PACIFICORP'S
APPLICATION TO CONSTRUCT
YREKA-WEED TRANSMISSION LINE UPGRADE PROJECT,
SOUTHERN PORTION
CPUC A.05-12-011
SCH #: 2007042080
Final Environmental Impact Report

Prepared for:
California Public Utilities Commission

Subject: NOTICE OF AVAILABILITY OF A FINAL ENVIRONMENTAL IMPACT REPORT (FINAL EIR):
PacifiCorp's Yreka-Weed Transmission Line Upgrade Project,
Southern Portion (A.05-12-011)
SCH No. 2007042080

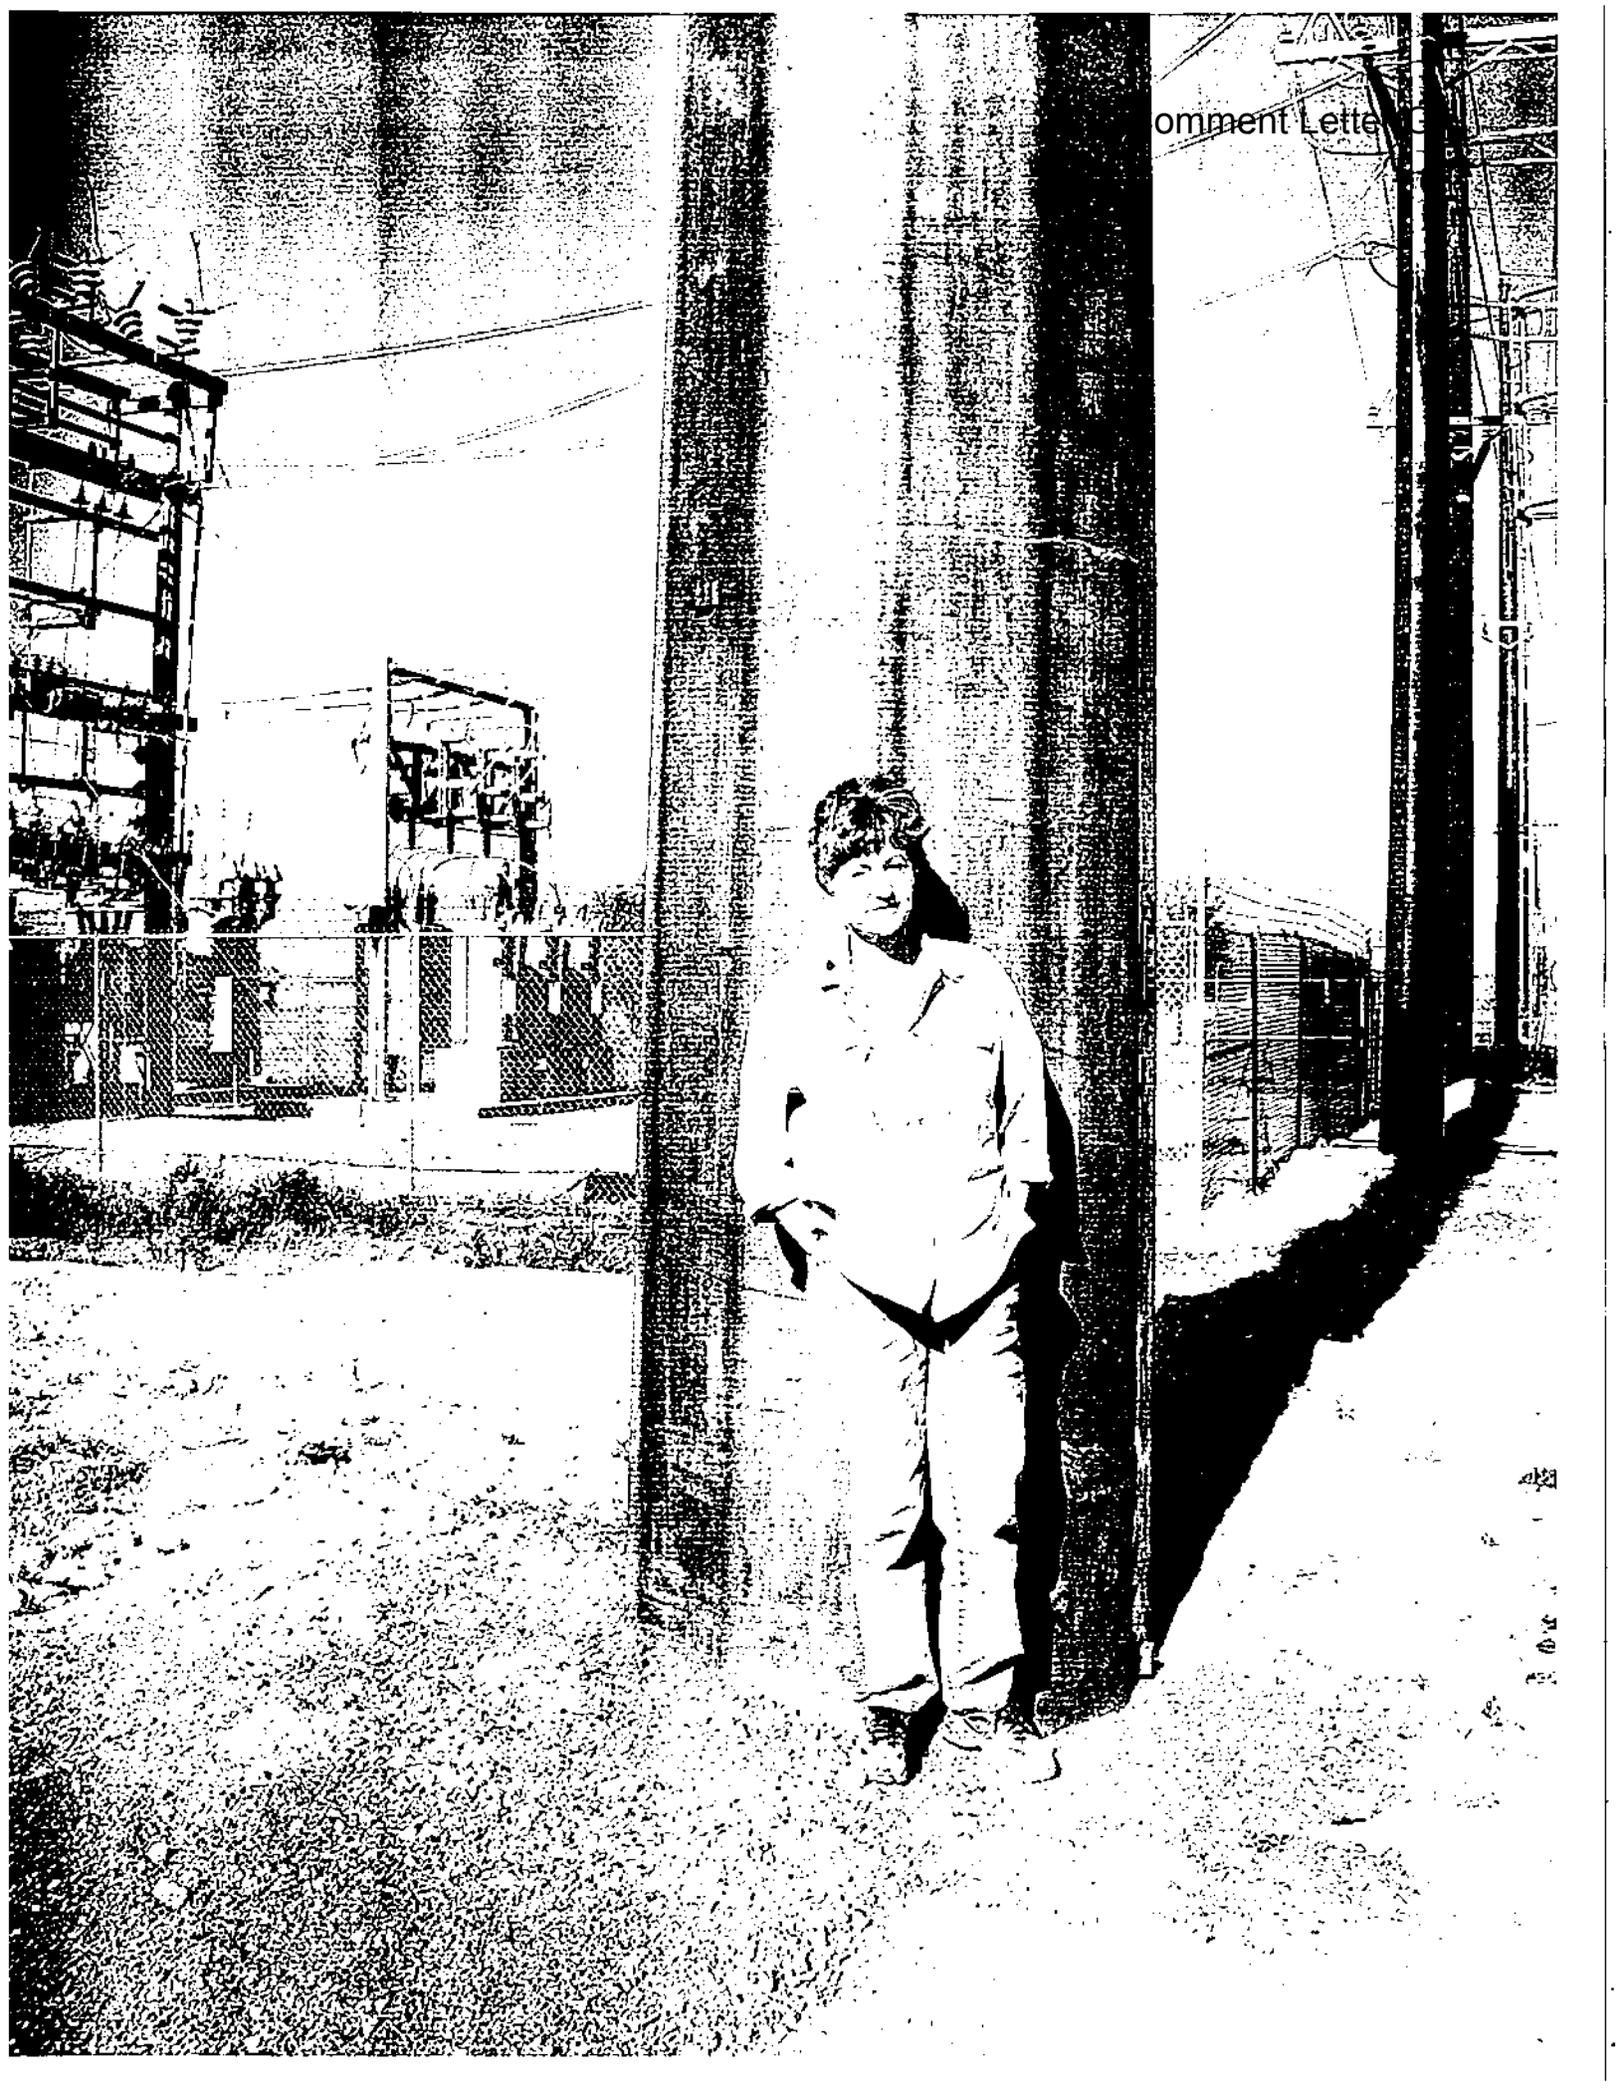
Similar measures can be taken along the Variation A and B routes to mitigate the visual impacts of the tall double-circuit vertical poles. Below we have identified potentially problematic poles, and recommended a replacement structure that under the DEIR's own analysis would, result in a less than significance impact. Adoption of these recommendations in the final EIR would result in alternatives that would not have any significant and unavoidable impact.

Variation A/B Pole Number	Recommended Replacement Pole	Resulting Visual Impact
Pole 16/47	Double-circuit horizontal configured pole	Pole would no longer be substantially taller than existing pole; would be an "incremental change" under the DEIR's standards
Pole 17/47	Double-circuit horizontal configured pole	Pole would no longer be substantially taller than existing pole; would be an "incremental change" under the DEIR's standards
Pole 5/48	Self-supported steel pole with horizontal configuration (TF285)	Pole would no longer be substantially taller than existing pole; need for guy wires would be eliminated; would be a less than significant impact under DEIR's analysis (See DEIR at 4.1-15)

Regarding Poles 17/47 and 5/48, recent refinements to the engineering design by the Applicant confirms that these two structures could each be replaced with a self-supporting steel TF285 design with horizontal davit arms rather than the vertically stacked conductor design identified in the DEIR. This change would result in about a 10 to 15 foot reduction in height for Poles 17/47 and 5/48 compared to what was simulated in Figures 4.1-21b and 4.1-23b for Pole 17/47, and Figures 4.1-24b for Pole 5/48. Also, for Pole 5/48, the guy wires that would cross Highway 97 and the stub pole on the south side of Highway 97 would no longer be needed if a TF285 structure is used. However, the TF285 design has wider horizontal cross-arms than the TF171 horizontal arm structures depicted in the alternative alignments along Highway 97 (approximately 7 feet versus 4 feet) and is larger in diameter (approximately 48 inches at the base versus 24 inches). Nonetheless, in this setting, the height of the structures would be the most distinguishable change from existing conditions because the lower portions of the structures would be partially screened by both existing vegetation and additional landscaping required under Mitigation Measures AES-VAR/A-1 and AES-VAR/B-1. So reducing the height of Poles 17/47 and 5/48 would lessen the degree of impact that these two structures would have in the Highway 97 viewshed.

Figure 4.7-2

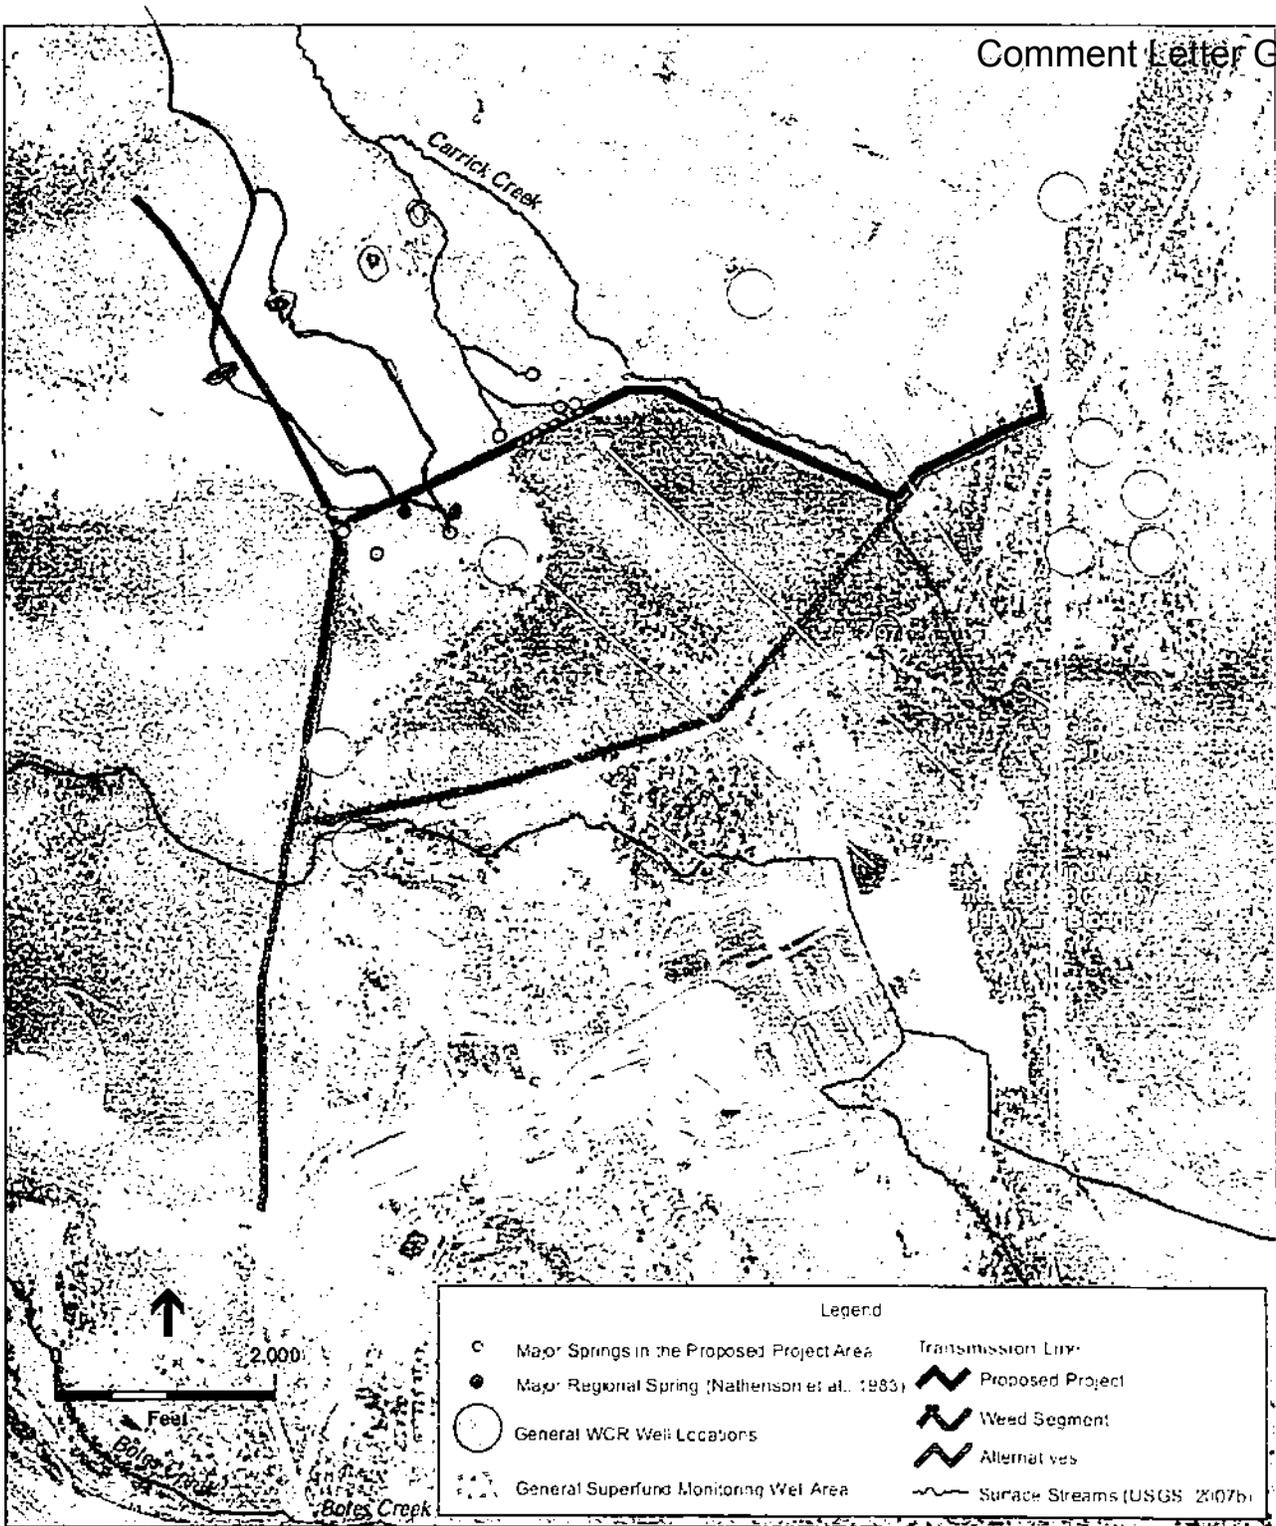
The DEIR has not done a good job of alleviating the Mackintoshes' fears regarding hydrological impacts, largely because it has not done a good job of identifying hydrological activity on their property. Figure 4.7-2 (mis-referenced as Figure 4.8-2 on page 4.7-8) identifies the springs and wells in the project area. The modified aerial photograph fails to identify at least two major riparian streams on the Mackintosh property that could be affected by the project, as well as a large stream on the Luiz property. We have included a corrected copy of Figure 4.7-2 with these comments. By ignoring the presence of these streams and springs, the DEIR has inadequately disclosed the environmental setting. By failing to discuss the impact to these streams and springs, the DEIR has inadequately analyzed the project.

Response G-15 The commenter states that the DEIR does not accurately identify the springs and streams that could be adversely affected by the Proposed Project. In particular, the commenter refers to the delineation of these features on Figure 4.7-2. The streams depicted on Figure 4.7-2 were derived from an *updated* database maintained by the U.S. Geological Survey; the springs depicted on Figure 4.7-2 were derived from topographic maps, literature, and observations made in the field.

Potential impacts from the Proposed Project on streams and springs are addressed, at length, on DEIR pages 4.7-16 through 4.7-25. Aside from the specific discussion and locations of the proposed steel pole installations, the analysis of the potential impacts of the Proposed Project on streams and springs is not limited to features depicted on Figure 4.7-2. The rationale and mitigation measures (where relevant) referenced in the analysis are applicable to all streams, springs, and groundwater formations within the Proposed Project area and are not limited to only those features illustrated on Figure 4.7-2. The intent of Figure 4.7-2 is not to delineate any and all features that could be impacted by the Proposed Project; rather, it is intended to illustrate local groundwater movement in relation to major spring formations and groundwater well locations.
